# Great Western Highway East – Katoomba to Blackheath

Submissions report

Transport for NSW | October 2022

Prepared by Aurecon Australasia in association with Mott MacDonald and Transport for NSW  
Publication number: 22.XXX

**FIGURE 3-1a:** Drainage catchments - Katoomba to Medlow Bath section

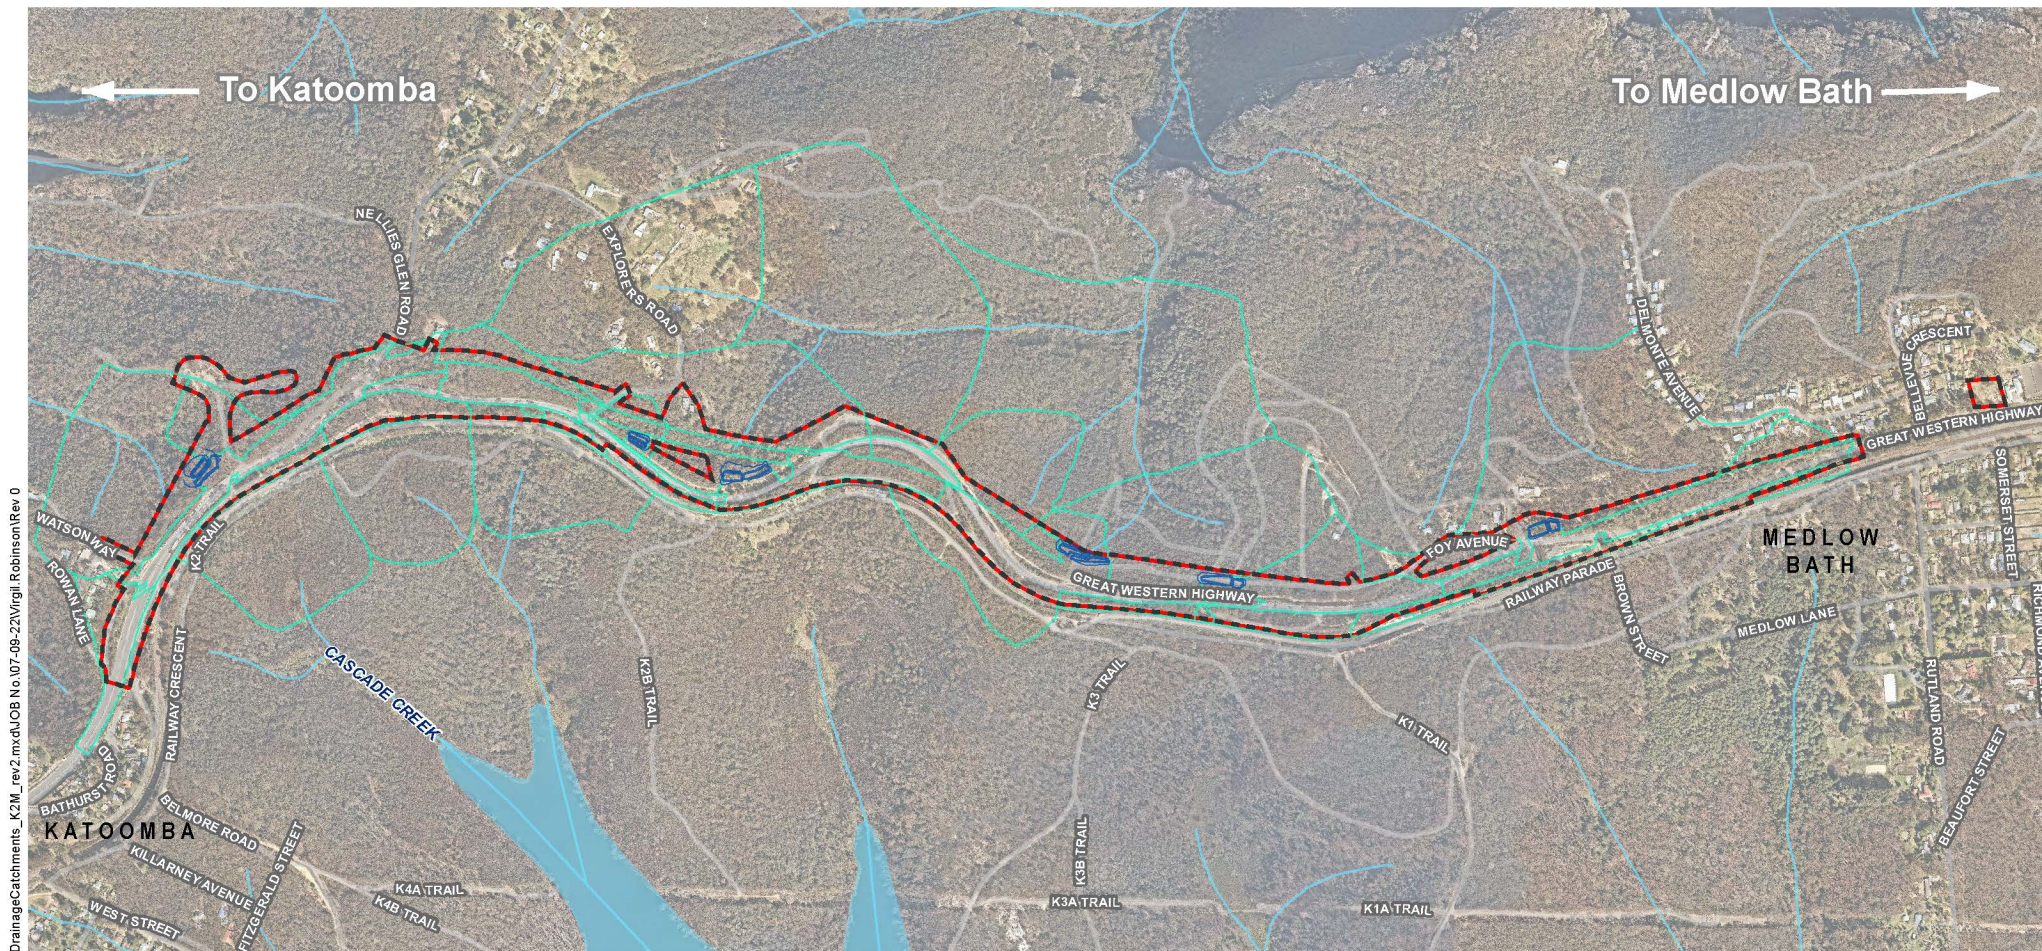
The catchments assessed as part of the proposal are shown in

Figure 3-1a-b. The western extension of the active transport trail outside the REF proposal area has been included in the operational MUSIC modelling carried out for the revised design (refer to Section 5.1).

Great Western Highway East **Submissions Report**  
FIGURE 4-1a: Revised design - Katoomba to Medlow Bath section

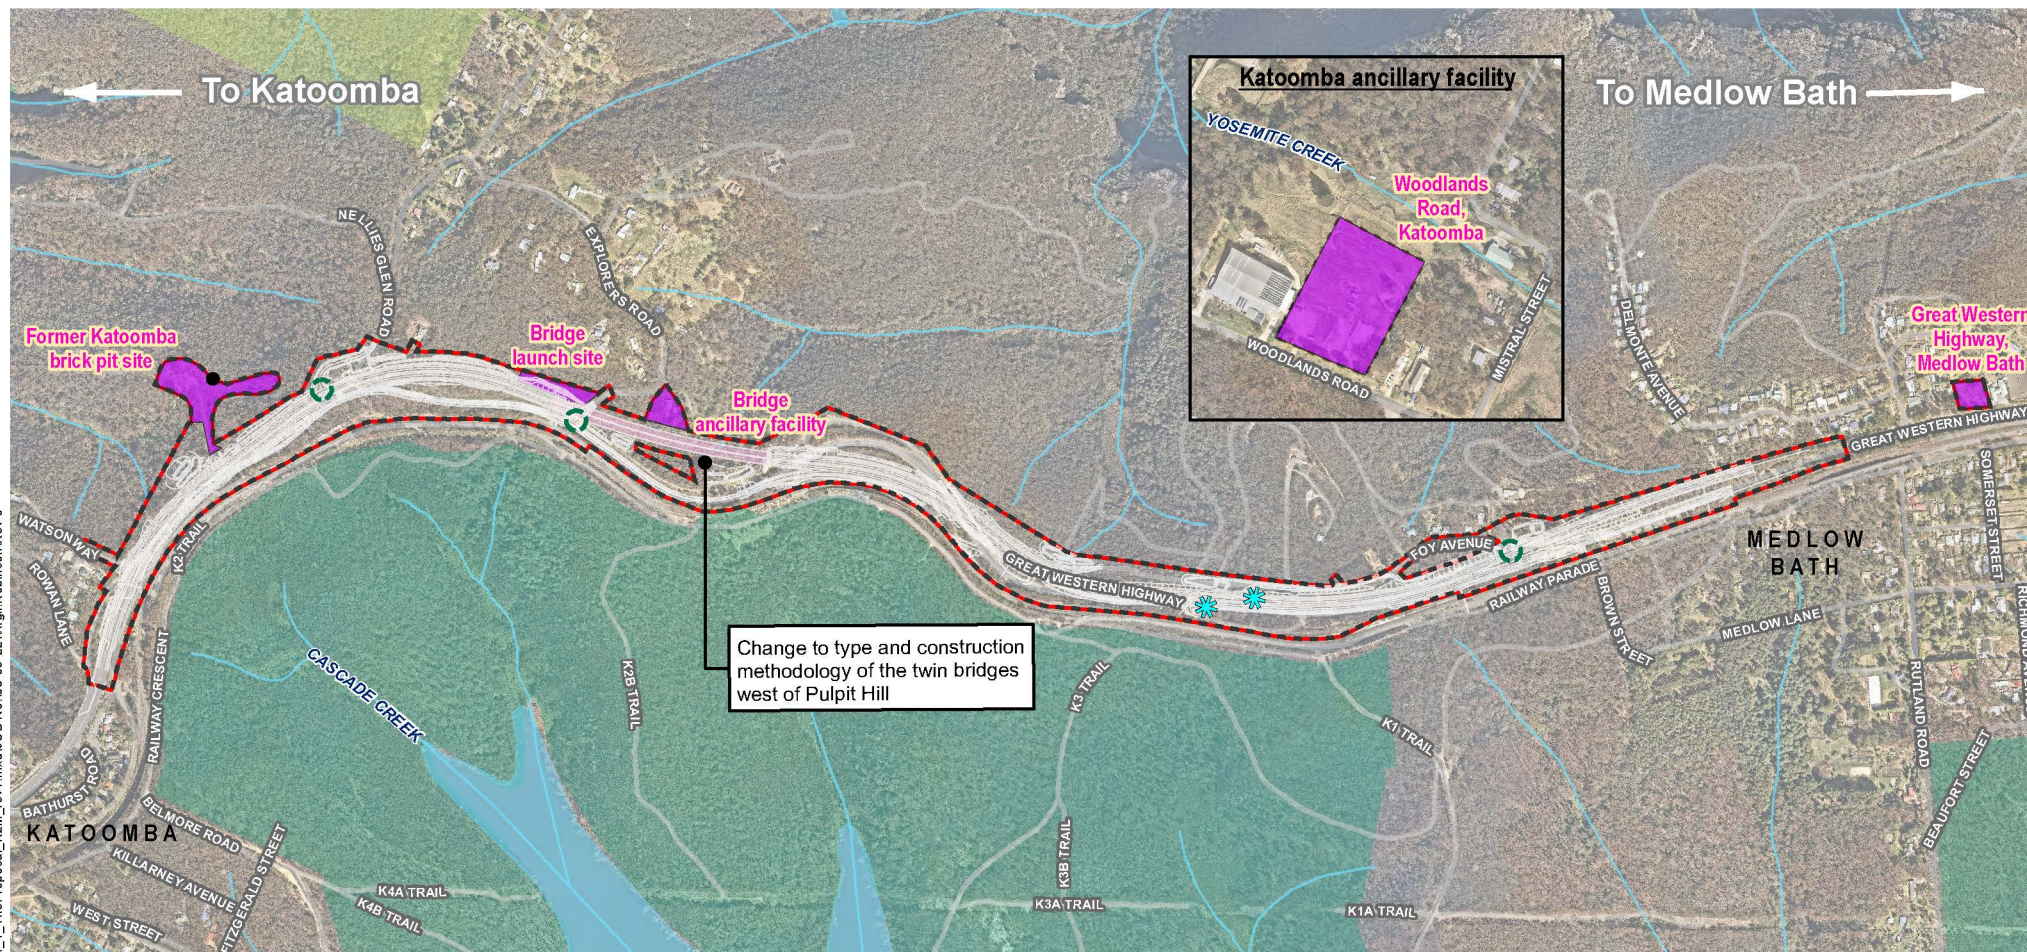
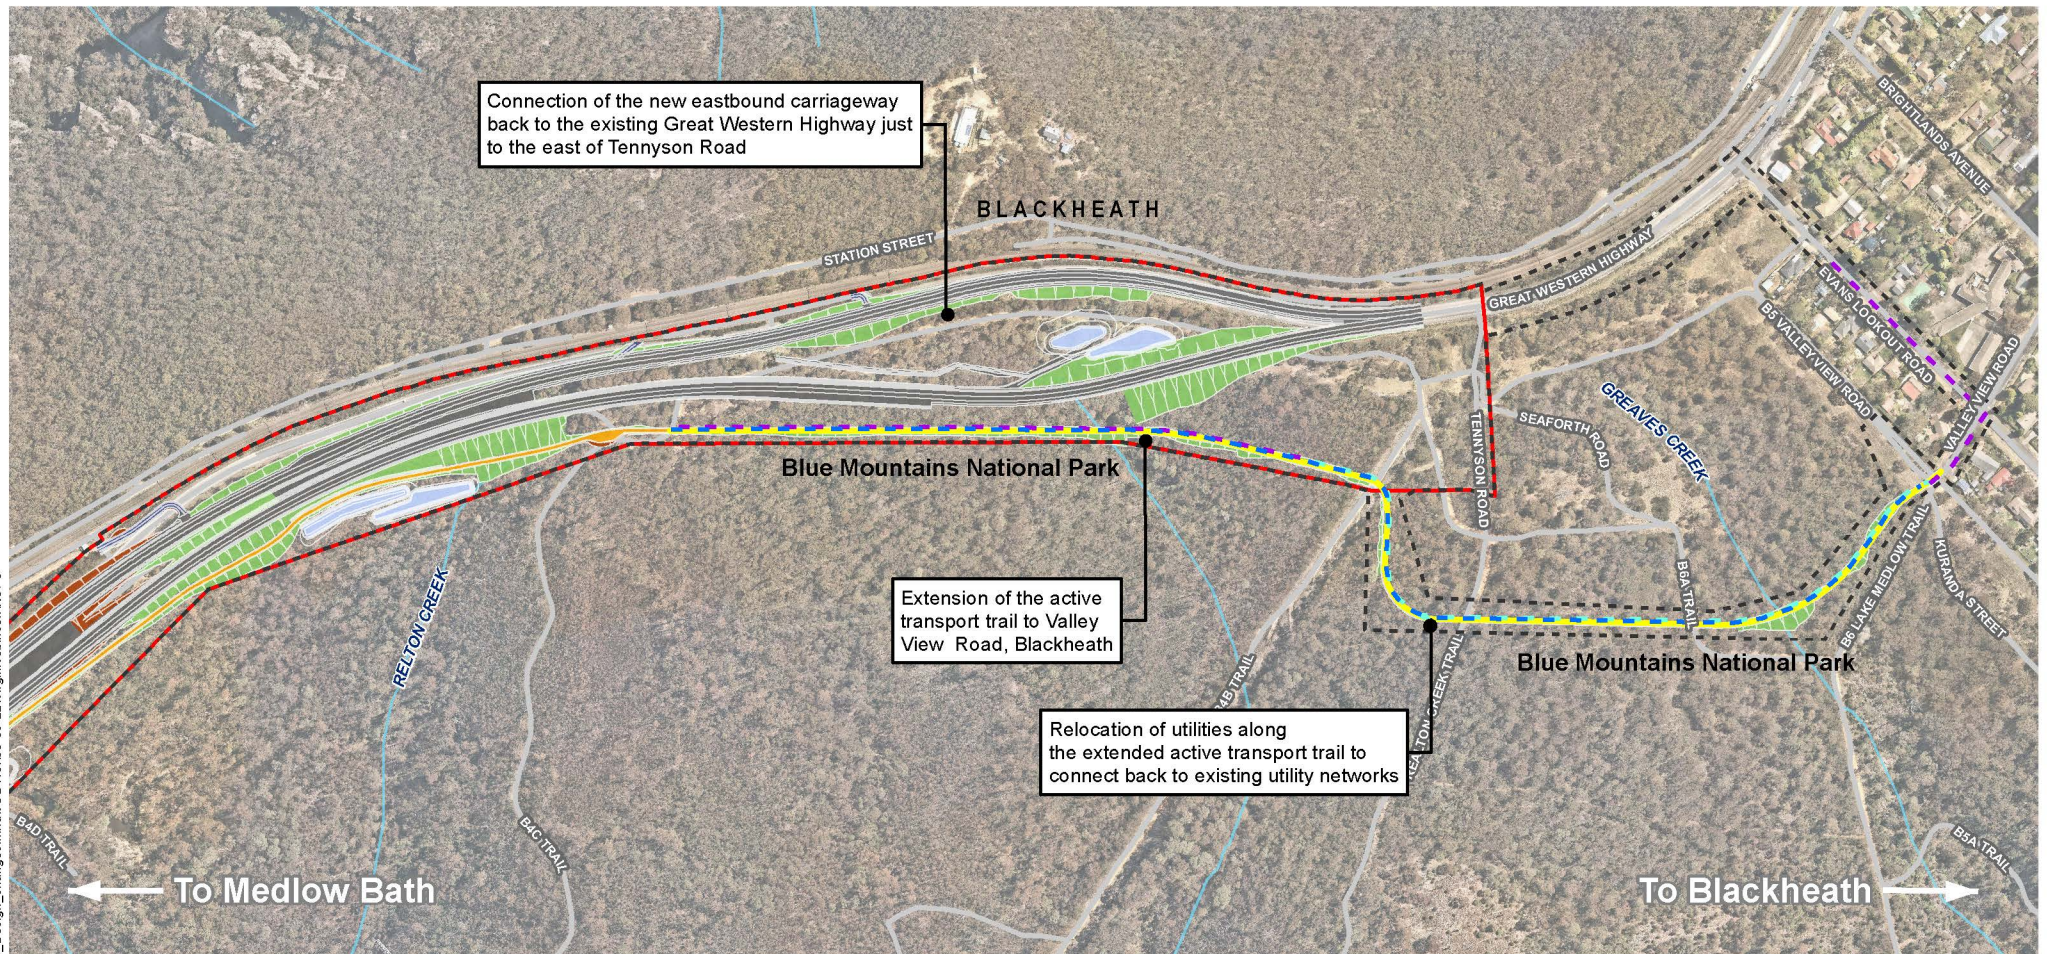
Figure 4-1a-b outlines the revised design and

Figure 4-2 indicates the locations where design changes are proposed in the revised design compared to the design outlined in the REF. These figures identify the revised proposal area, which includes a western extension of the REF proposal area towards Blackheath and has been developed as the footprint required for the construction of the revised design.

- Minor adjustments to maintenance access and rail corridor interfaces in both sections of the proposal.
- Type and construction methodology of the twin bridges west of Pulpit Hill to introduce bridge designs that minimise environmental impacts.

- Optimising the lane alignment tie-in near Coachhouse Lane.
- Sealing of unsealed sections of active transport trail.
